# UNITED STATES PATENT AND TRADEMARK OFFICE

APPLICATION NO.	FILING DATE	FIRST NAMED INVENTOR	ATTORNEY DOCKET NO.	CONFIRMATION NO.
09/729,443	12/04/2000	Steven T. Jaffe	BP1235	6265
51472 7590 09/24/2007 GARLICK HARRISON & MARKISON P.O. BOX 160727 AUSTIN, TX 78716-0727			EXAMINER TORRES, JUAN A	
			ART UNIT 2611	PAPER NUMBER
			MAIL DATE 09/24/2007	DELIVERY MODE PAPER

# Office Action Summary

## **DETAILED ACTION**

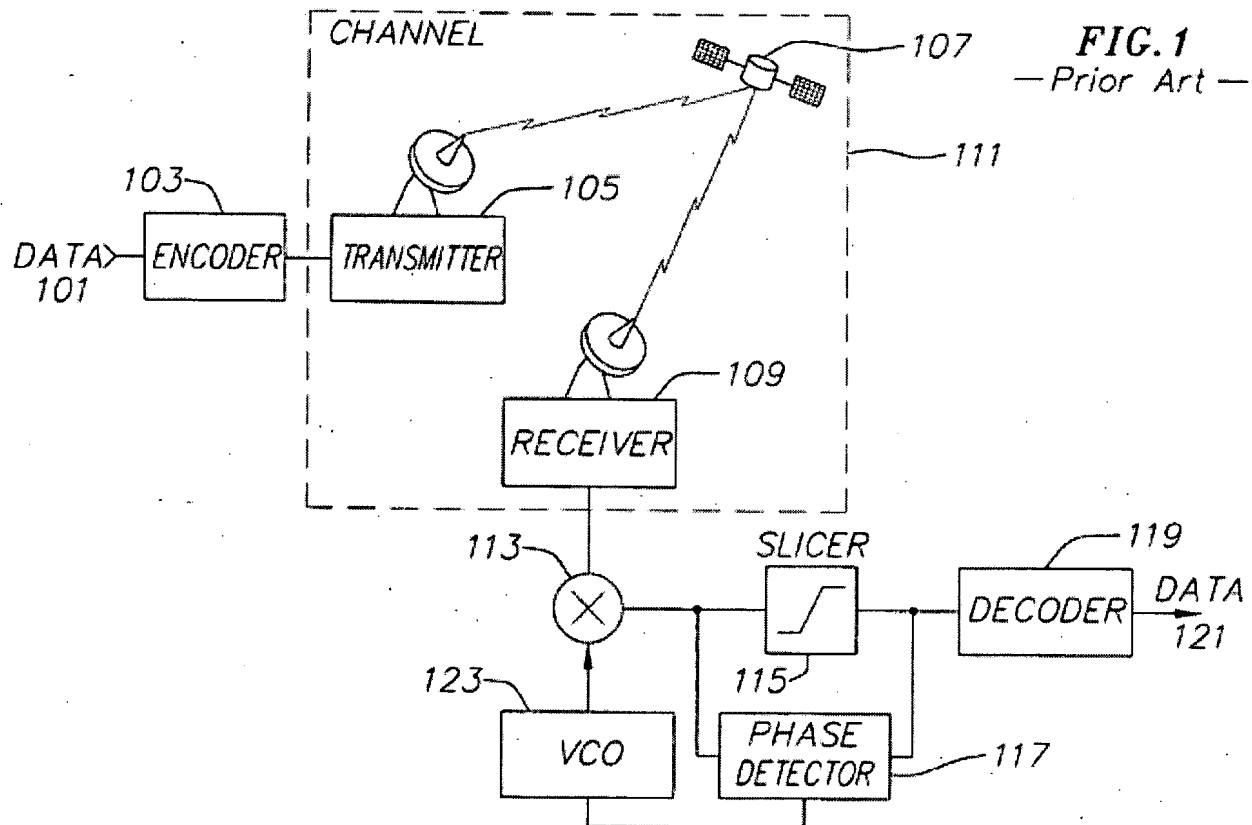
It is clear from the detail description and the drawings that the invention is to substitute the slicer in figure 2 by a Viterbi decoder because "Turbo encoder 200 is a parallel concatenated encoder. Parallel concatenated codes ("turbo codes") allow communications systems to operate near the Shannon capacity. However, when operating in this region, the signal to noise ratio may be very low. This low signal to noise ratio ( $E_s/N_0$ ) can make synchronization with a received signal difficult"....."A Viterbi decoder uses the past and future data as well as correlations within the data to produce a current symbol that is more likely to be correct than if only the present data is used (such as with a typical data slicer). In the embodiment illustrated in FIG. 3, future data is not available, so the Viterbi decoder 301 will examine past and present data in order to produce a symbol, which is more likely to be accurate than one determined by a slicer mechanism such as illustrated in FIG. 2".

Figure 3

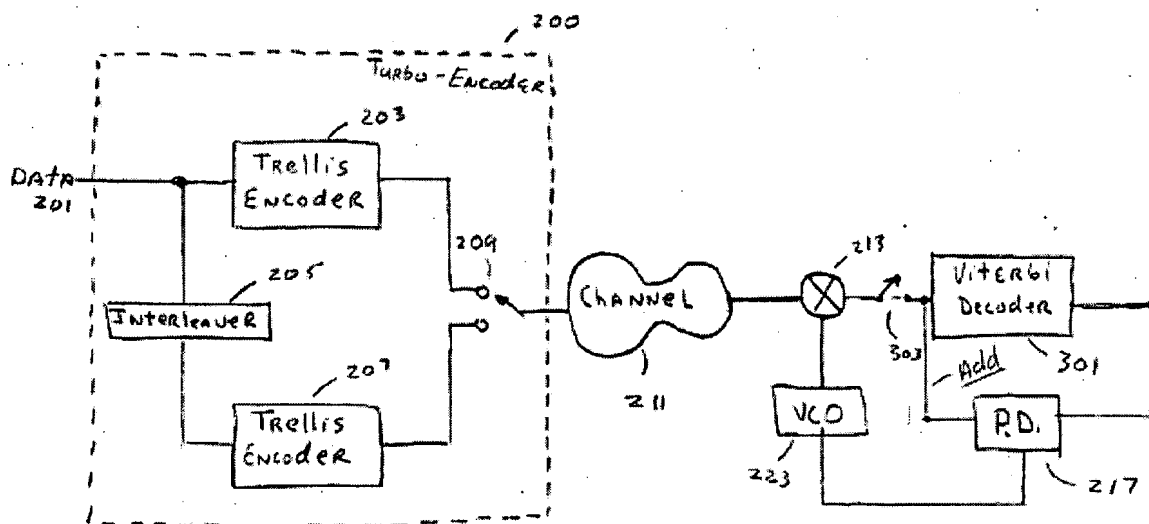
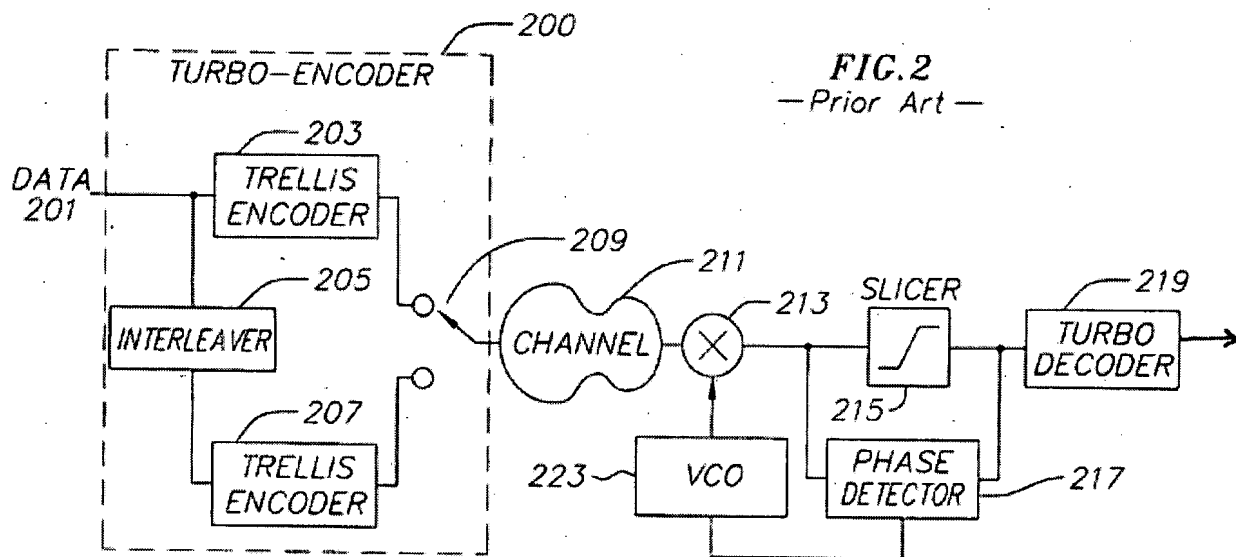
The drawings are objected to because Figures 3 and 4 are of not enough quality; it is suggested to send new figures 3 and 4 in the same quality that figures 1 and 2 (see below). Corrected drawing sheets in compliance with 37 CFR 1.121(d) are required in reply to the Office action to avoid abandonment of the application. Any amended replacement drawing sheet should include all of the figures appearing on the immediate prior version of the sheet, even if only one figure is being amended. The figure or figure number of an amended drawing should not be labeled as "amended." If a drawing figure is to be canceled, the appropriate figure must be removed from the replacement sheet, and where necessary, the remaining figures must be renumbered and appropriate changes made to the brief description of the several views of the drawings for consistency. Additional replacement sheets may be necessary to show the renumbering of the remaining figures. Each drawing sheet submitted after the filing date of an application must be labeled in the top margin as either "Replacement Sheet" or "New Sheet" pursuant to 37 CFR 1.121(d). If the changes are not accepted by the examiner, the applicant will be notified and informed of any required corrective action in the next Office action. The objection to the drawings will not be held in abeyance.

Fig. 1. Classical concatenation of a carrier recovery loop and a Turbo-decoder.

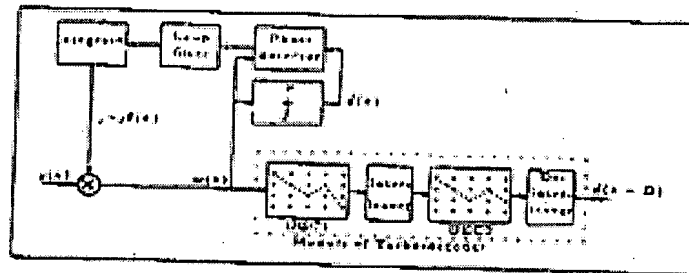
The reference used by the Examiner under statutory bar 102(b) of 35 USC (Mottier "Influence of tentative decisions provided by a Turbo-decoder on the carrier synchronization: Application to 64-QAM signals", COST 254 Workshop on Emerging Techniques for Communication Terminals, Toulouse France July 7-9, 1997, pages 326-330) present the same idea: Figure 1 present the use of the classical slicer in the carrier synchronization, similar to the figure 2 of the present Application
